**[Issue No.]** T12-0013

**[Title]** Version upgrade of Q Series positioning module

**[Relevant Models]** QD75D1, QD75D2, QD75D4

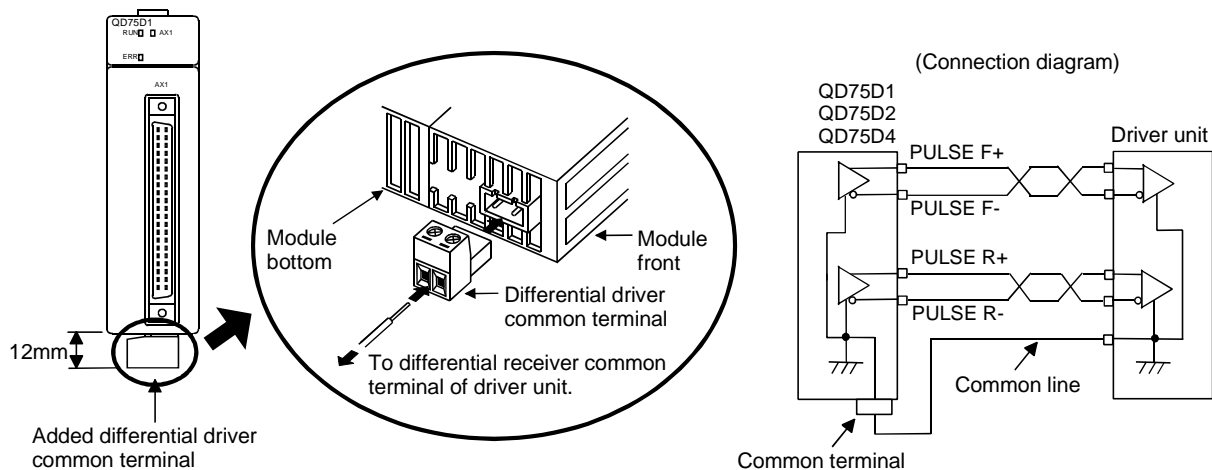
The positioning module (QD75D1/QD75D2/QD75D4) manufactured from January, 2002, has been upgraded with new hardware.

The differential driver common terminal has been added to the external interface.

A potential difference may occur between the differential driver common terminal and the differential receiver common terminal of the driver unit, depending on the environment.

To eliminate the potential difference, connect these terminals. This improves the signal stability.
